Determination 2017/088

Regarding the code-compliance of a façade system proposed for remediation work to an apartment building at 12 Selwyn Road, Howick, Auckland

Figure 1: Typical construction of the original façade system (not to scale)

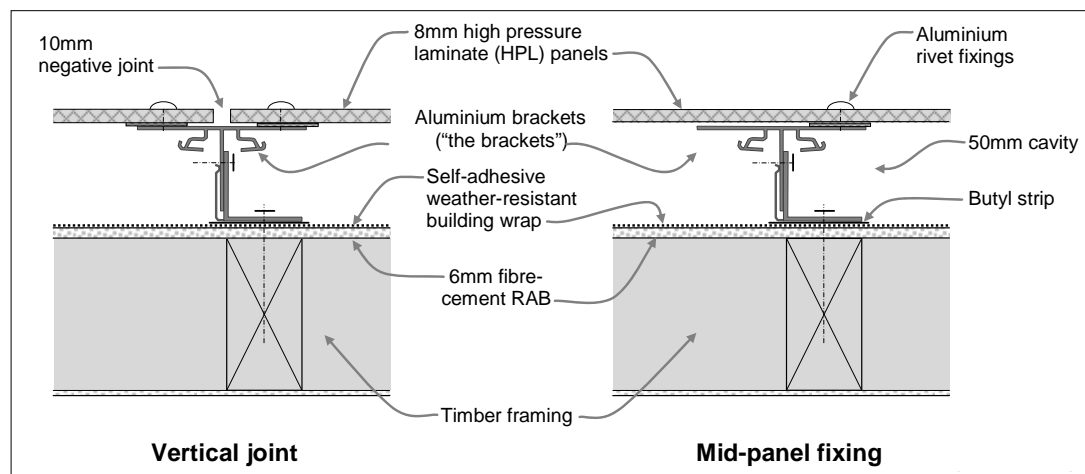
- 2.3.1 The original façade system comprised a high-pressure laminate panels (the HPL panels⁷) riveted to an aluminium rail system which provides a 50mm cavity behind the HPL panels as indicated in Figure 1.

- Fixing with aluminium rivets rather than steel screws would probably cause more panels to fall, or panels to fall sooner – so the change does not improve or maintain performance compared to that in the fire test.
- This might not result in increased flaming above the windows opening, but increases the hazard of falling materials onto fire fighters or others below and fire could spread from falling flaming panels depending on the panel's combustibility.
- Increasing fixing spacing is unlikely to improve performance compared to the fire tested system and whether performance would be maintained is unknown.

- The base assembly is to be timber frame with unspecified cavity insulation instead of steel frame with (mostly likely) glass fibre insulation as tested.
- 6 mm fibre cement sheet is to be used on the outside of the framing instead of [16mm] gypsum plasterboard. The latter would be expected to have much better fire-resistant properties than the former.
- The aluminium support structure differs from that tested.
- The panels are fixed to the support structure with aluminium rivets instead of steel screws as tested.
- The panel fixings may have larger spacings compared to that tested.
- The mineral fibre insulation fire stopping at each level is possibly omitted but present in the test assembly.

- The modified façade system replaces the aluminium rivets with 5.0mm diameter stainless steel rivets spaced in accordance with the tested panels. The proposed steel rivets have a greater cross section than the tested screws, so should perform equally if not better than the tested wall.

Figure 2: The original, modified, and 285-tested façade systems (not to scale)

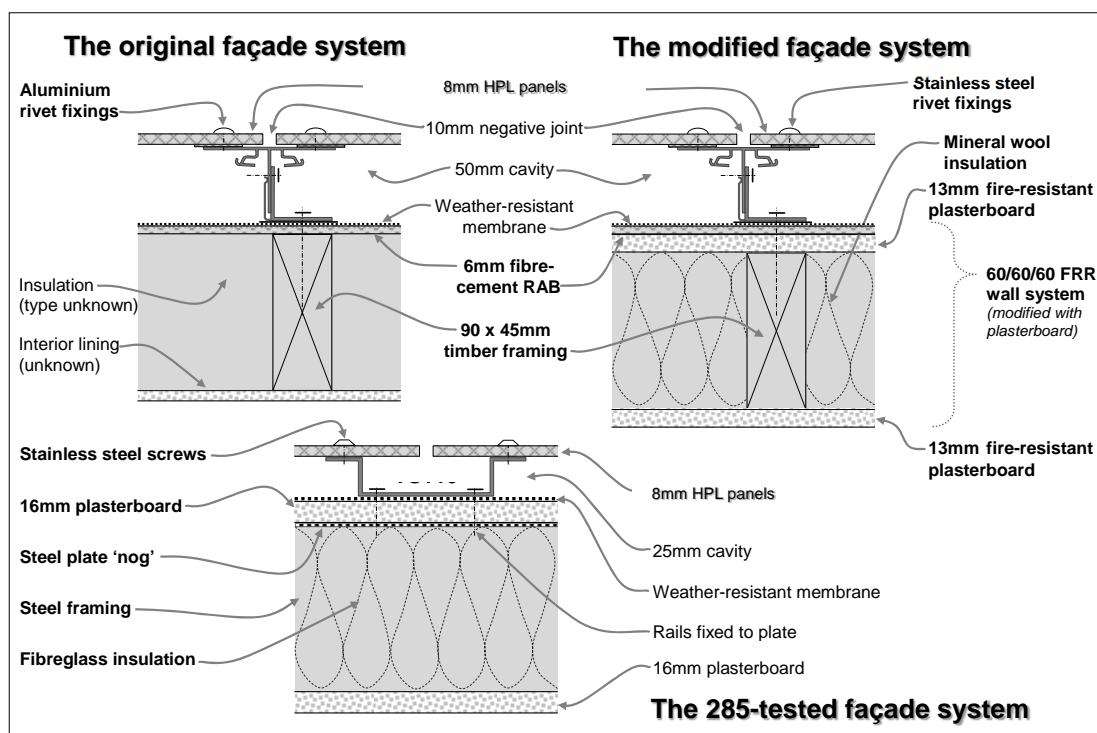
2.5.1 Following the issue of the first draft determination the original façade system was amended to the modified façade system. The original facade system, the modified façade system and the 285-tested system are shown in Figure 2, with significant component differences shown in bold.

5.2.4 The fire scientist noted that components of the base wall assembly used in the tested wall as shown in Table 2 would provide little fuel should an exterior fire breach the outer layer of gypsum board and reach the framing and cavity insulation (see Figure 2).

Component	Differences identified	Additional information provided / the modified façade system
1 2 Base wall assembly	Timber frame with unspecified cavity insulation instead of steel frame.	Base wall to be an established 60/60/60 FRR timber-framed wall, with additional layer of 13mm fire-resistant plasterboard beneath the fibre-cement RAB.
	6mm fibre-cement RAB to outside of framing instead of 16mm gypsum plasterboard.	
3 Aluminium support structure	Aluminium support structure for the HPL panels differs from that tested.	<ul style="list-style-type: none"> Proposed structure has same physical properties as tested product. Dead load, seismic and wind loads drive the support structure sizing.
4 Panel fixing method	Panels fixed to support structure with aluminium rivets instead of steel screws.	Stainless steel rivets to be used.
5 Spacing of fixings	Fixings may have larger spacings compared to that tested.	Spacing to accord with NFPA 285 test.

6 Insulation and cavity barriers	Mineral fibre insulation fire stopping at each level is possibly omitted but present in the test assembly.	Cavity barriers are required and will be installed. There is no intention to delete these.

5.8.2 The fire scientist reviewed the modified façade system taking into account fire test results for the proposed base wall. Some concerns were discussed with the fire consultant, who provided an amended proposal (see Table 4) that included an additional layer of 13mm fire-resistant plasterboard beneath the fibre-cement RAB.
